MICHELSON WATER RECYCLING PLANT PHASE 2 & 3 CAPACITY EXPANSION PROJECT

Final Supplemental Environmental Impact Report No. 1
SCH# 2011031091

Prepared for
Irvine Ranch Water District

October 2012

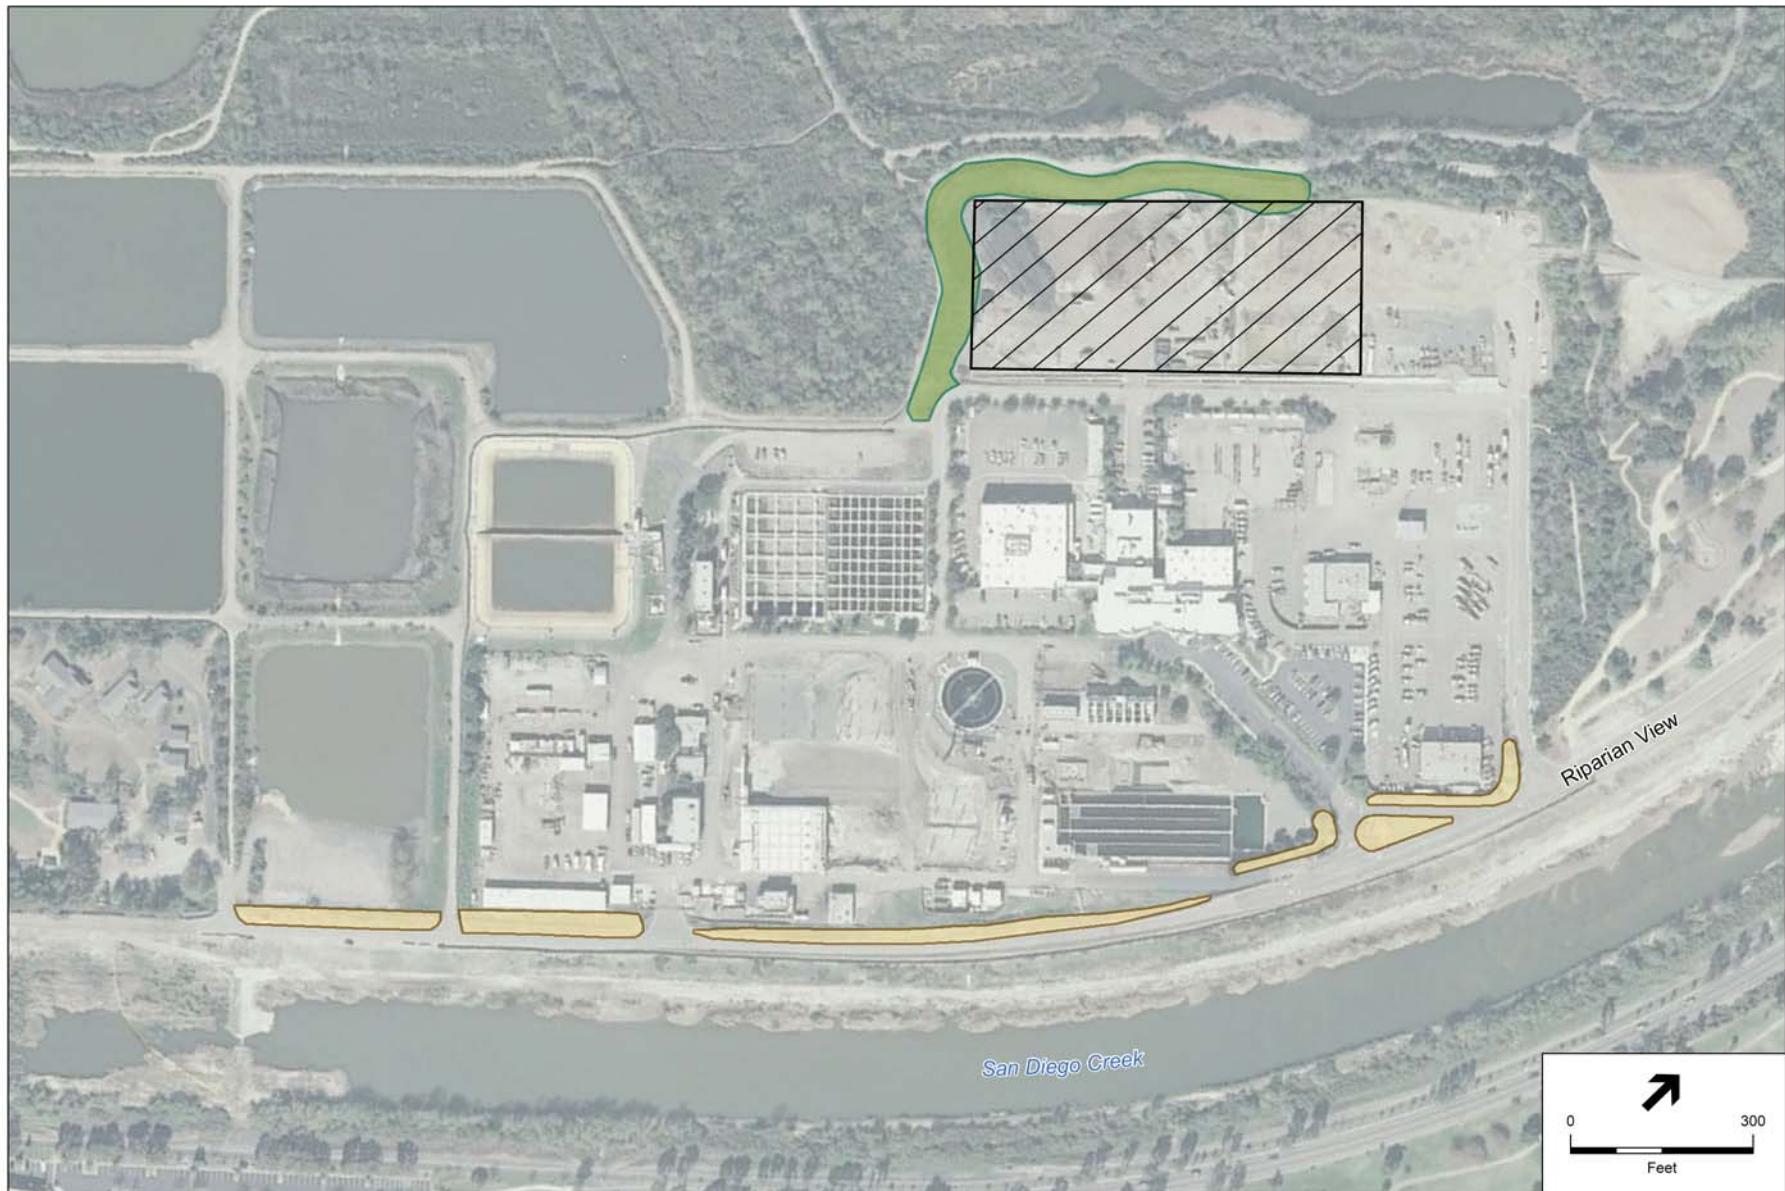
The City of Irvine requests the inclusion of topographic information to show the heights of the surrounding properties relative to the project site, including building heights to demonstrate the relative height of the proposed biosolids treatment facility. Please also provide a text discussion to describe the quantitative details in the exhibits.

Relative building heights are inherent in the visual simulations shown in Figures 3.1-5 through 3.1-15 in the Draft SEIR. In response to the comment, IRWD has prepared additional simulations to illustrate the relative height of the proposed facilities when viewed from the Rancho San Joaquin area. **Exhibit B** shows the approximate location and maximum height of the proposed biosolids handling building (70 feet) when viewed from the Rancho San Joaquin Golf Course and Irvine Historical Society to the east. The project site is located in a topographic depression relative to these visual vantage points. Therefore, the proposed 70-foot structure would not alter the existing skyline and would blend into the visual landscape of urban development, proportionate to surrounding buildings. **Exhibit B** supports the conclusions of the Draft SEIR that although the proposed project would introduce a new feature into the visual landscape, the effects of the proposed project on scenic views and visual character would be less than significant.
